HISTORIC AND DESIGN REVIEW COMMISSION

HDRC CASE NO: 2022-399
ADDRESS: 363 NORTH DR
LEGAL DESCRIPTION: NCB 7026 BLK 5 LOT 16, E11 FT OF 18
ZONING: R-6, H
CITY COUNCIL DIST.: 7
DISTRICT: Monticello Park Historic District
APPLICANT: Thomas Gandy/GANDY THOMAS R
OWNER: Thomas Gandy/GANDY THOMAS R
TYPE OF WORK: Exterior modifications, fenestration modifications
APPLICATION RECEIVED: July 24, 2022
60-DAY REVIEW: Not applicable due to City Council Emergency Orders
CASE MANAGER: Edward Hall

363 NORTH DRIVE,
SAN ANTONIO, TX

DEMOLITION FLOOR
PLAN AND ELEVATIONS

2 FRONT ELEVATION
AD-10 1/4"=1'-0"

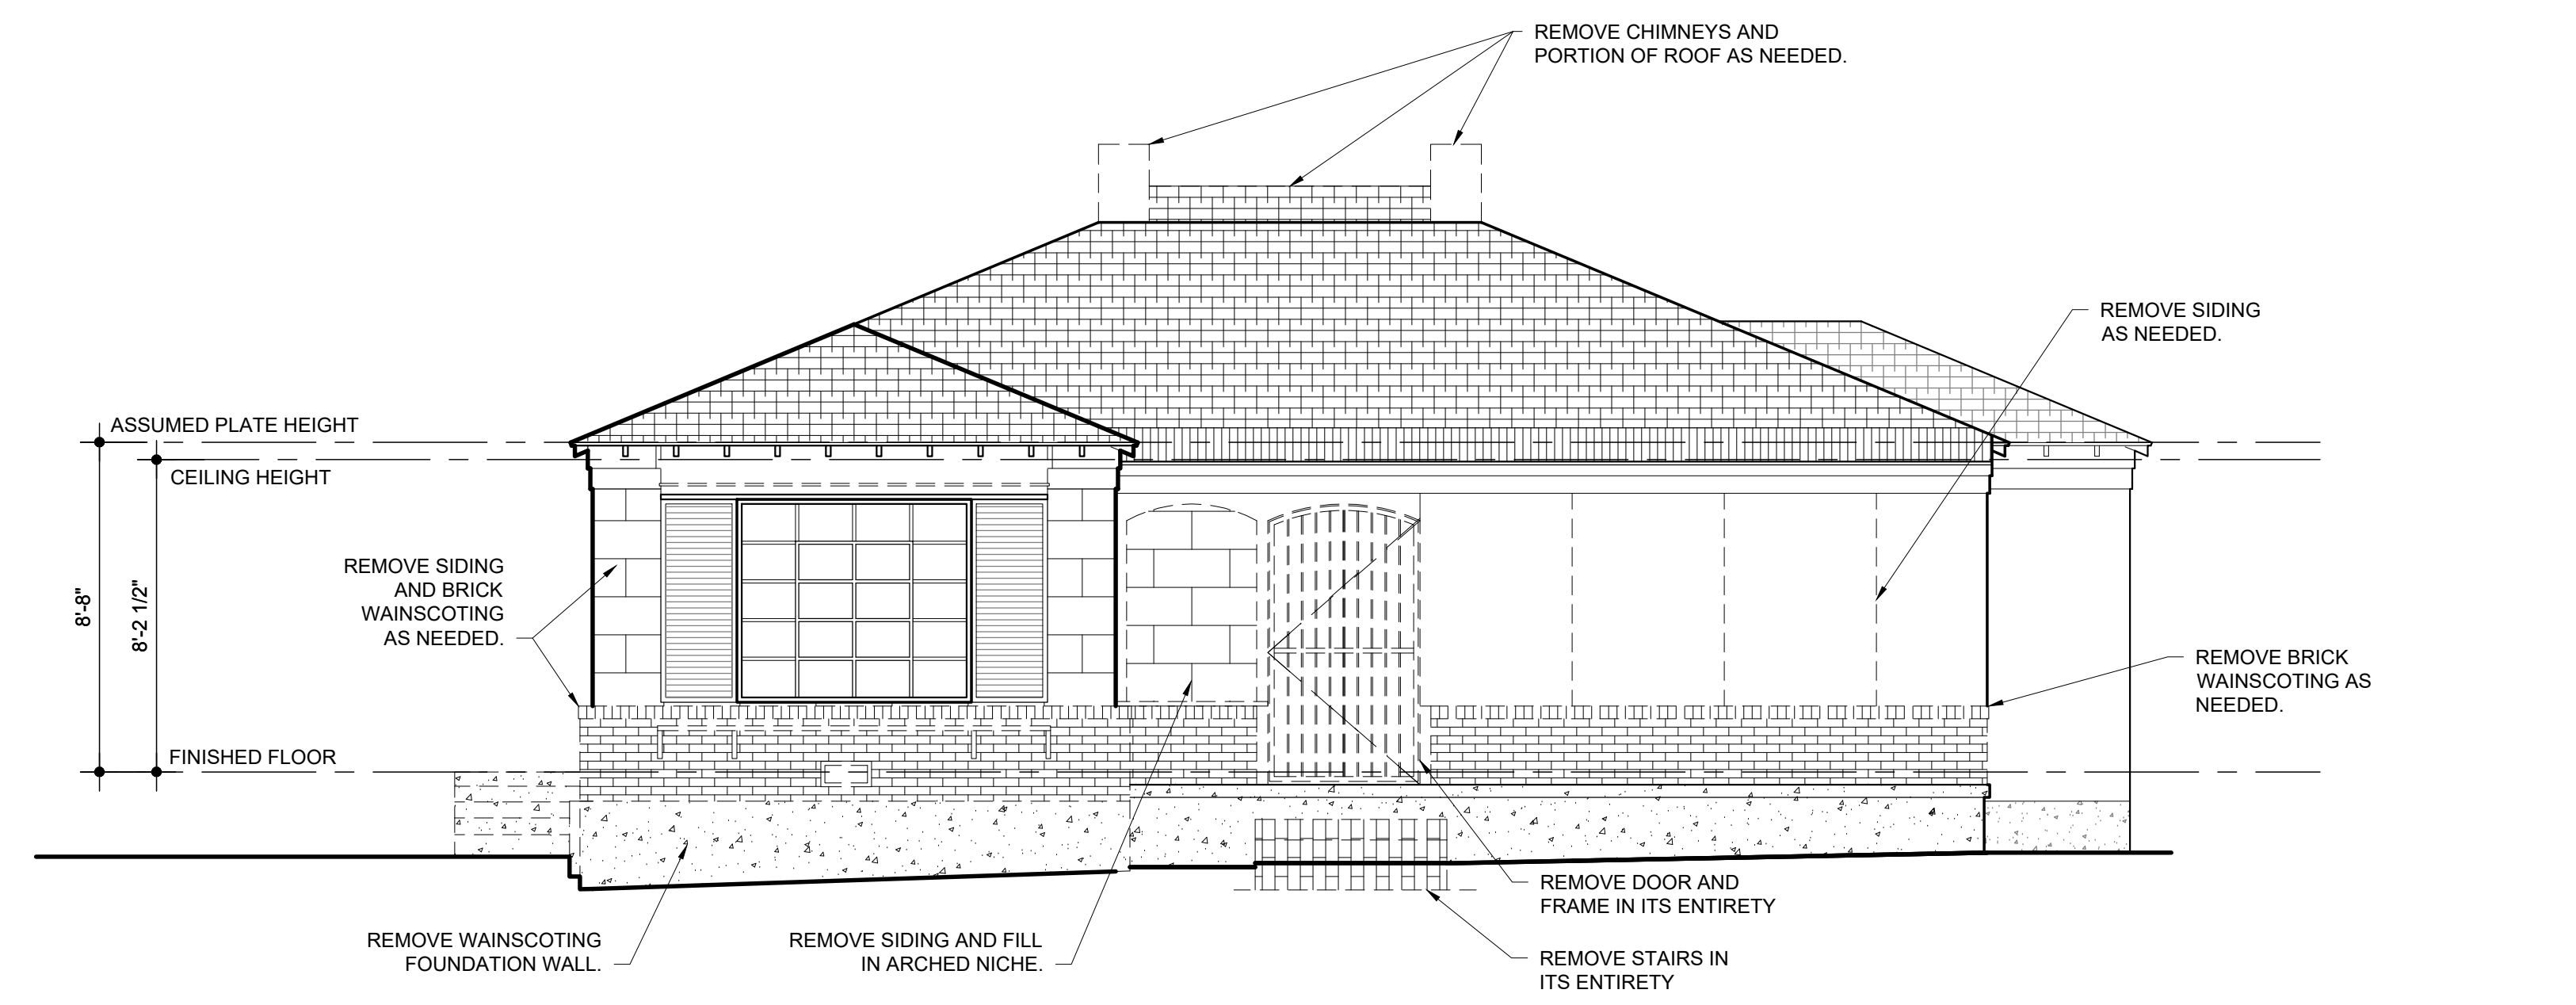
- d. EXTERIOR MODIFICATIONS (Front Façade) – The applicant has proposed to perform modifications to the front façade to include the installation of two, one over one windows on the front façade. This wall plane is not original and is the front of a previously enclosed front porch. The Guidelines for Exterior Maintenance and Alterations 7.A and B. note that front porches should not be enclosed. When porches are enclosed, the Guidelines note that they should function and visible read as a porch. Per photos, the front porch has been enclosed with screening elements since 2007, at least. Staff finds that either windows should be added across the entirety of the enclosed porch to read as an open element with visible porch columns, or that the structure should be returned to its previous condition.

- f. FRONT PORCH STEPS – The applicant has proposed to install new, rounded concrete porch steps as well as a concrete apron to the proposed porch steps. The existing steps are clad in brick, but feature a minimal design and a width that is slightly wider than that of a pedestrian door opening. There is no historic precedent of an alternative porch design on site or within the district. Staff finds that the existing porch steps form should be maintained. In-kind replacement, with concrete would be appropriate, with no change to profile.

2. Staff does not recommend approval of item #2, modifications to the front façade, as noted in finding d. Staff recommends that either windows be added across the entirety of the enclosed porch to read as an open element with visible porch columns or that the structure be returned to its previous condition.

4. Staff does not recommend approval of item #4, the installation of new, rounded concrete porch steps and a concrete apron as noted in finding f. In-kind replacement, with concrete would be appropriate, with no change to profile.

3 LEFT ELEVATION
AD-10 1/4"=1'-0"

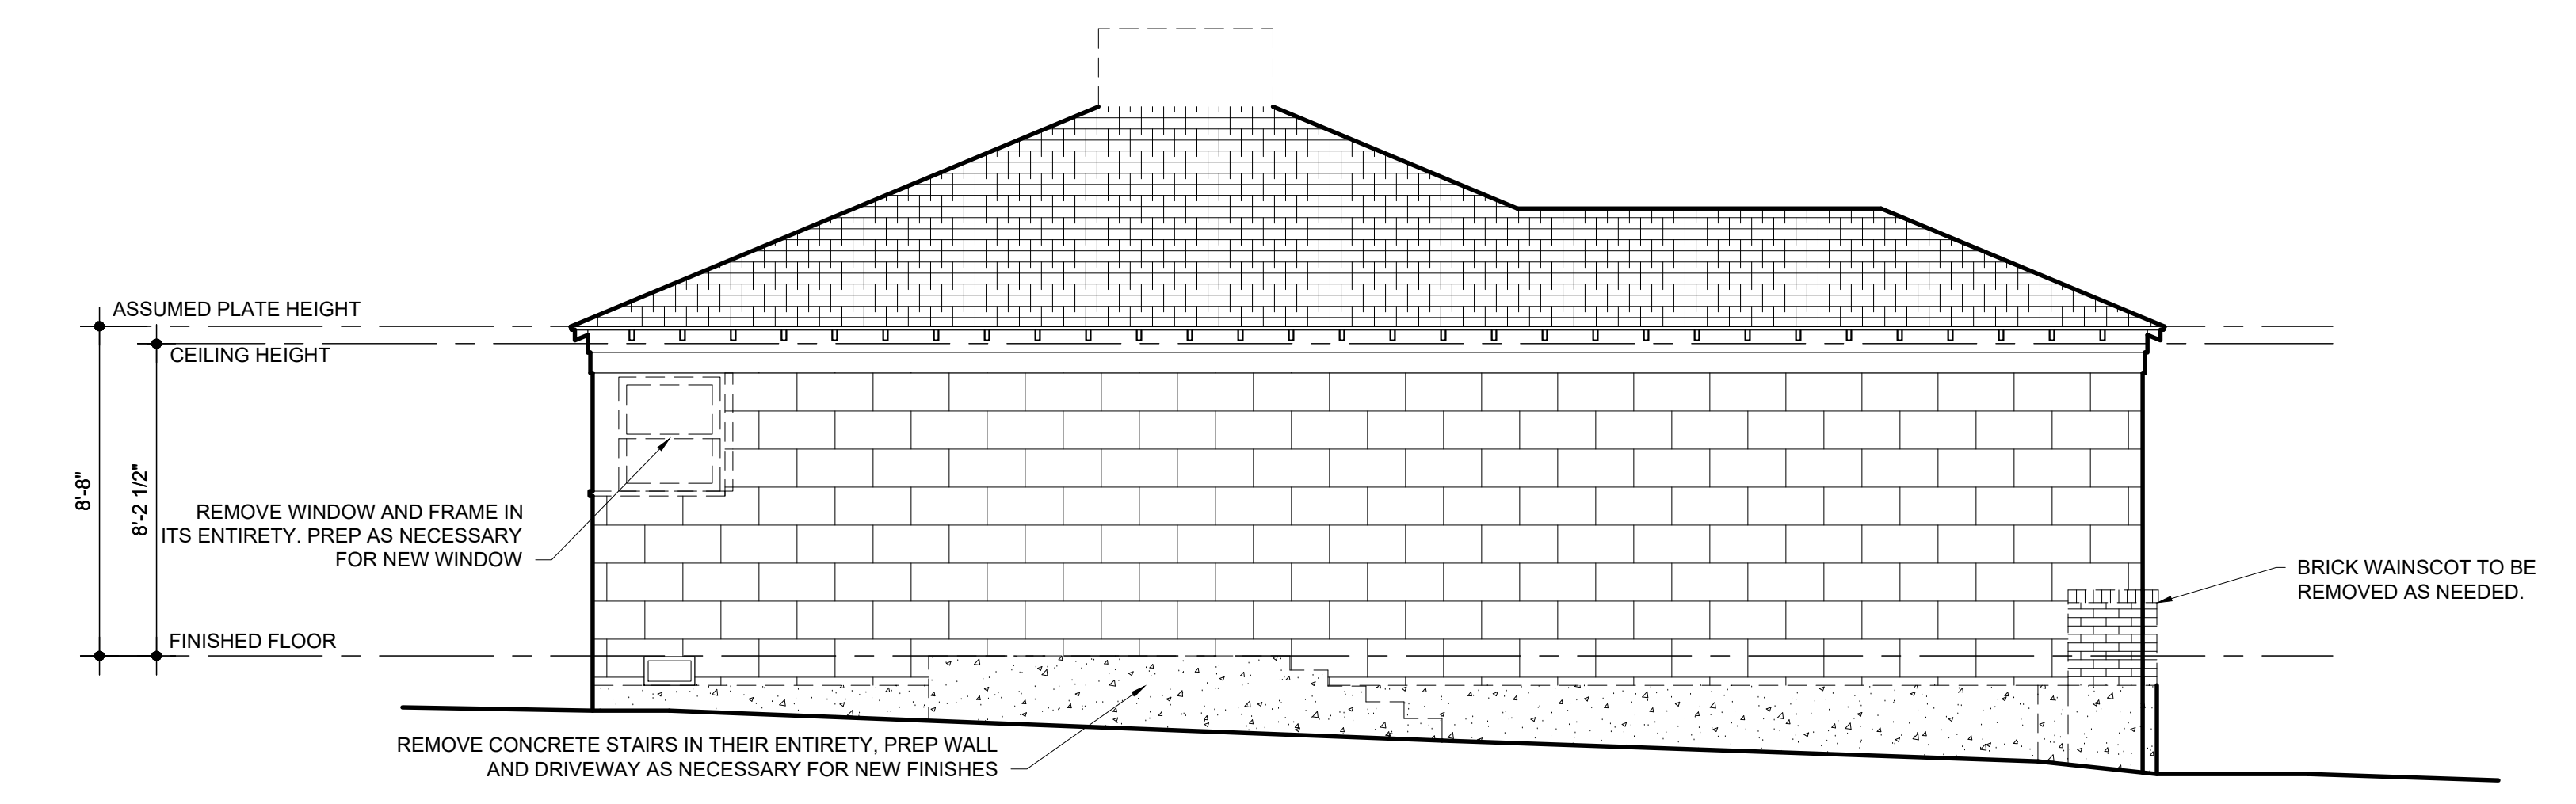
- e. EXTERIOR MODIFICATIONS (Side Façade) – The applicant has proposed to perform modifications to the side (west) façade to include the removal of an existing door opening, and the removal of an existing concrete stoop and steps. Per the Guidelines for Exterior Maintenance and Alterations 6.A.i., exiting window and door openings are to be preserved. The proposal to remove the existing, side door is inconsistent with the Guidelines. Staff finds this door opening should be preserved in its original location. Additionally, staff finds that the side stoop and porch steps are an original element and should be preserved.

3. Staff does not recommend approval of item #3, modifications to the side (west) façade to include the removal of an existing door opening, and the removal of an existing concrete stoop and steps, as noted in finding e. Staff recommends that the door opening, concrete stoop and stairs be preserved.
